Application for Works Approval

Works Approval Number	W3183/2026/1
Applicant	Endurance Mining Pty Ltd
ACN	686 341 471
File number	APP-0032449
Premises	ABRA Base Metals Project Mining Tenement G52/292 MEEKATHARRA WA 6642 As defined by the premises map attached to the issued works approval
Date of report	16/03/2026 (FINAL)
Decision	Works approval granted

The Applicant proposes to increase tailings storage capacity at Abra Base Metals Project (the premises) by constructing and operating an additional tailings storage facility (TSF). The facility, known as TSF Cell B2, will involve an expansion of the existing TSF.

Figure 2: TSF Cell B2 including monitoring bore locations

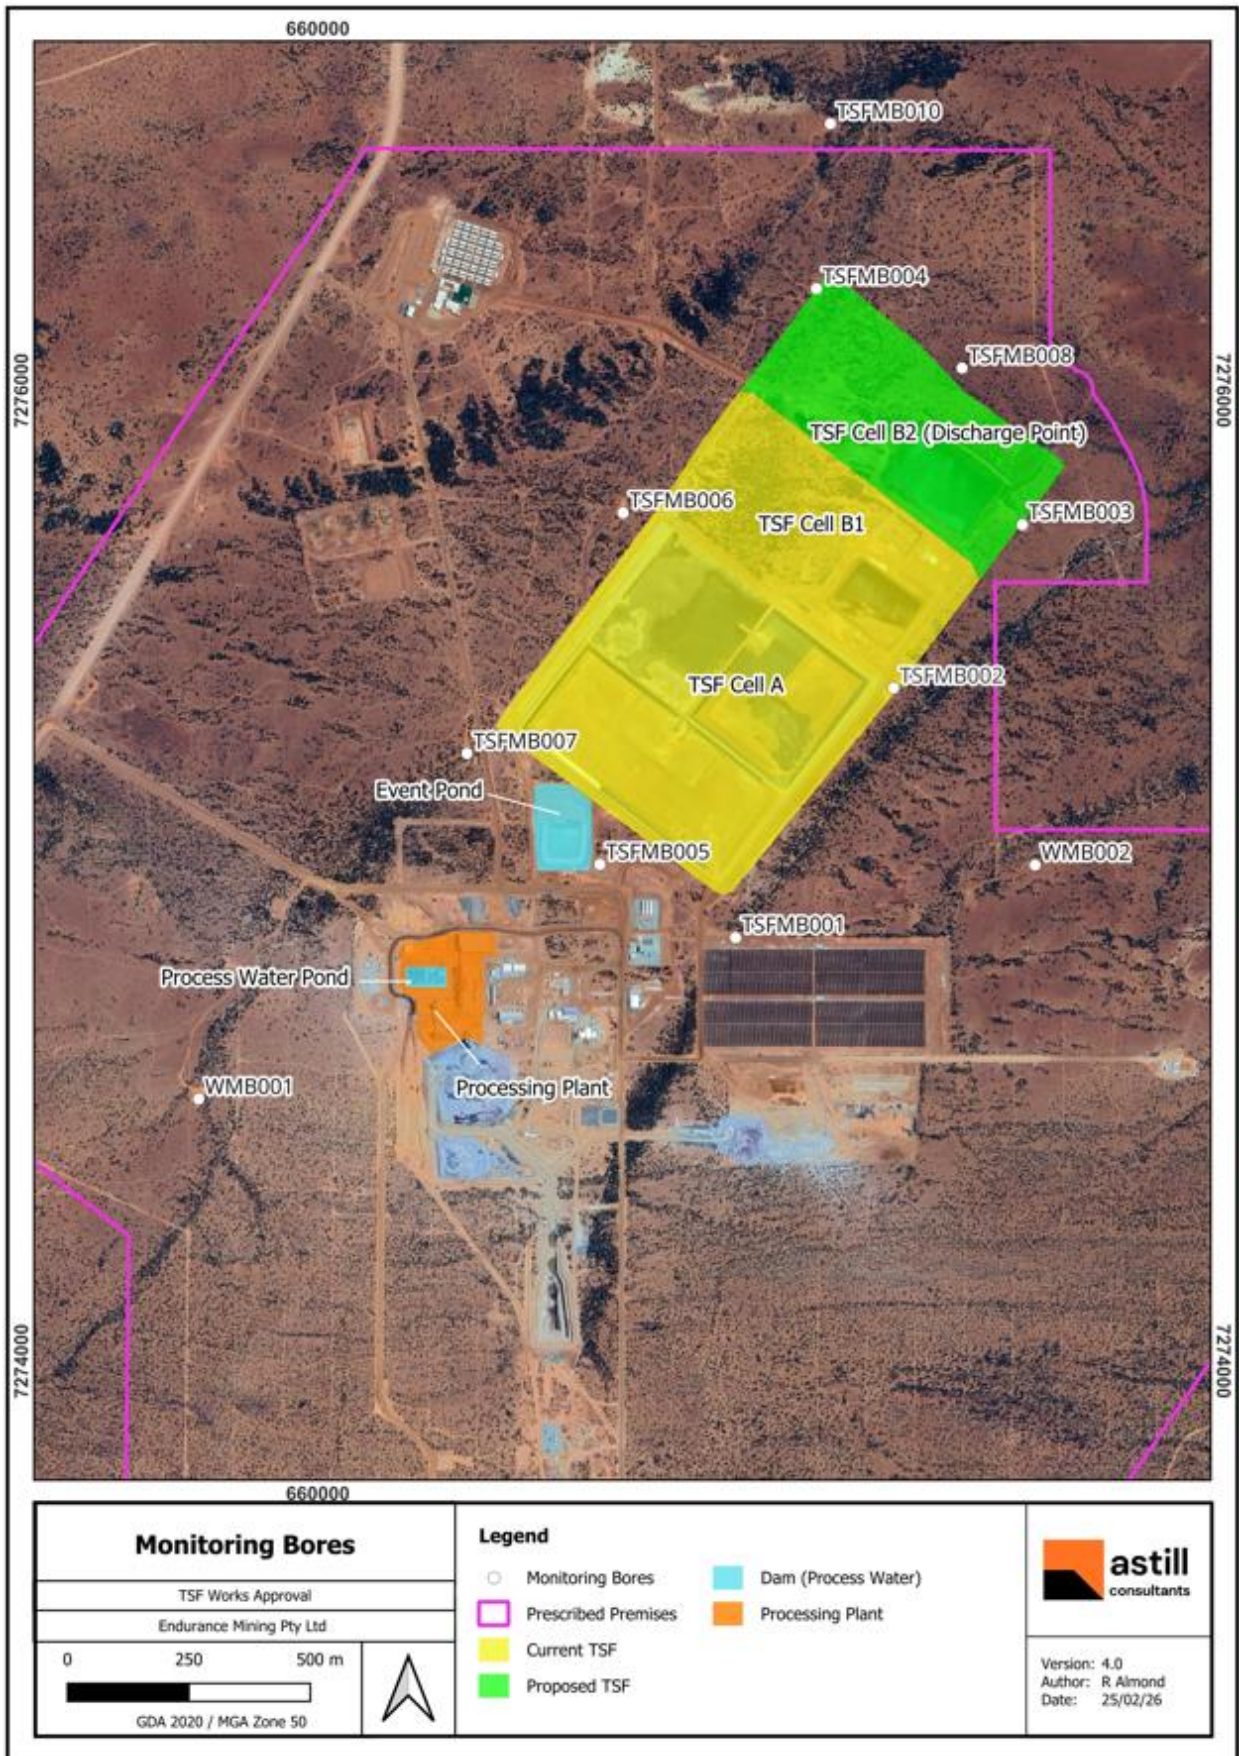
Consultation method	Comments received	Department response
Request for comments - Jidi Jidi Aboriginal Corporation. Advised of proposal on 19/01/2026	Period to receive comments ended 10/02/2026. No comments received.	N/A
Meeting held with Endurance Mining Pty Ltd on 14/10/2025	<p>Scoping meeting to discuss submission of an application for a works approval for construction of TSF Cell B2 tailings storage facility at the Abra Base Metals Project.</p> <p>Attendees: Gavin Lee (Sustainability Manager) – Abra Mining Pty Ltd, Wayne Astill – Astill Consultants, Paul Anderson (Environmental Officer) – Department of Water and Environmental Regulation, Jarrod Abrahams (Manager, Resource Industries) - Department of Water and Environmental Regulation.</p>	N/A
Email received from Gavin Lee – Endurance Mining Pty Ltd on 26/02/2026	An updated groundwater monitoring bore map provided. The original submitted map with the application had some groundwater monitoring bores omitted and was out of date.	Works Approval updated with latest map

Figure 3: Distance to sensitive receptors

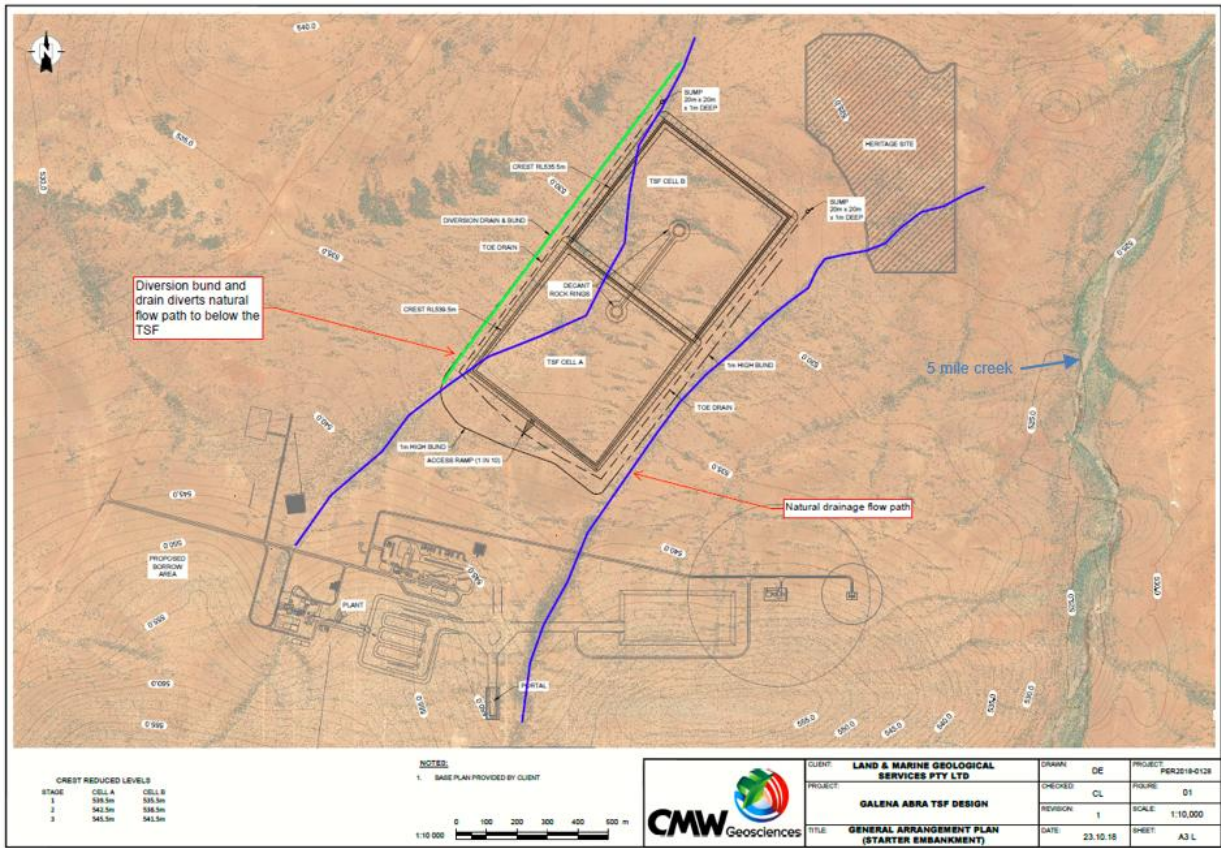
Applicant was provided with draft documents on 12/03/2026	<p>Response received from Applicant 12/03/2026.</p> <p><i>Endurance Mining has reviewed the documents and has only one comment. In Table 2 of the decision report, the location is correct; however, the reference to the “Nicols Springs heritage site” should be amended, as the area contains an Aboriginal site, but it is not referred to as “Nicols Springs heritage site” it should read as Aboriginal heritage site.</i></p> <p><i>Other than the above, Endurance Mining has no further comments on the draft instrument or decision report and wishes to waive the 21-day comment period.</i></p>	<p>DWER notes and supports the variation.</p> <p>Decision report updated.</p>
